# Access Compliance Report

## Public Rights-of-Way

### (Curb Ramps)

Intersection ID: 31257	Main Street: EWEN_CR	Cross Street: SACKETT_WY	Location: NE
ADA ID: 4301821050DE	Ramp Type: PerpDiag	Initial Pass/Fail: Fail	Overall Compliance: No
		Severity Score: 18.75

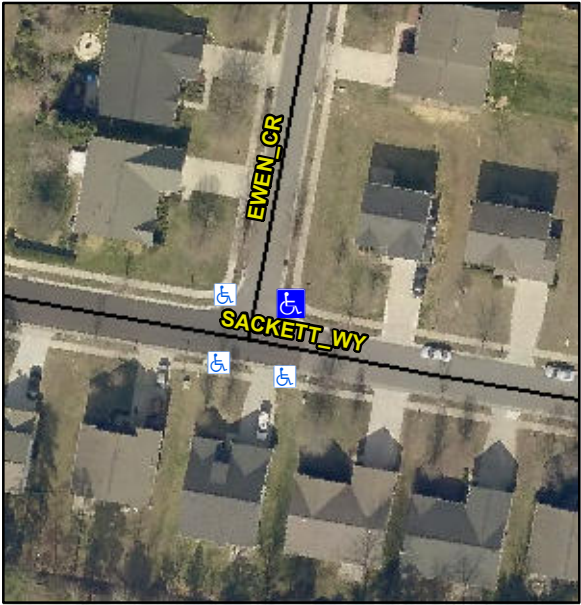
Codes/Mitigation Info/Possible Solution			Field Measurements/Component Compliance		
	Possible Solutions:		<b>Compliance</b>	<b>Description</b>	<b>Data</b>
	<b>Remove &amp; Replace Curb Ramp With Two New Directional Ramps or Equivalent.</b>		<b>Yes</b>	Ramp Length (in)	6.8
			<b>No</b>	Ramp Width (in)	2.1
			<b>N/A</b>	Flare Type LT	N/A
			<b>N/A</b>	Flare Slope LT (%)	N/A
			<b>N/A</b>	Flare Traversable LT?	N/A
			<b>N/A</b>	Landing Length (in)	N/A
			<b>N/A</b>	Landing Width (in)	N/A
			<b>N/A</b>	Landing Slope (%)	N/A
			<b>N/A</b>	Landing X Slope (%)	N/A
<p>Surveyor Notes:</p> <p><b>N/A</b></p> <p>PROW/ADA:</p> <p><b>R304.5.1, R304.5.3</b></p>			<b>N/A</b>	Flare Type RT	N/A
			<b>N/A</b>	Flare Slope RT (%)	N/A
			<b>N/A</b>	Flare Traversable RT?	N/A
			<b>N/A</b>	DWS Provided?	N/A
			<b>N/A</b>	DWS Contrast?	N/A
			<b>N/A</b>	DWS Length (in)	N/A
			<b>N/A</b>	DWS Full Width?	N/A
			<b>N/A</b>	DWS Offset (in)	N/A

<b>N/A</b>	Shared Landing?	N/A
			<b>N/A</b>	Gutter Ponding?	N/A
			<b>N/A</b>	Gutter Lip Ht (in)	N/A
			<b>No</b>	Painted X Walk1?	No
				X Walk 1 Direction	To W
			<b>N/A</b>	X Walk 1 Width (in)	N/A
			<b>0.9</b>	X Walk 1 Slope (%)	N/A
			<b>0.9</b>	X Walk 1 X Slope (%)	N/A
			<b>N/A</b>	Ramp inside XWalk1?	N/A
			<b>N/A</b>	Road Slope (%)	N/A
			<b>N/A</b>	Road X Slope (%)	N/A
			<b>N/A</b>	Any Obstructions?	N/A
				Obstruction Type	
			<b>N/A</b>		N/A
			<b>Yes</b>	Surface Condition? (G/P)	Good
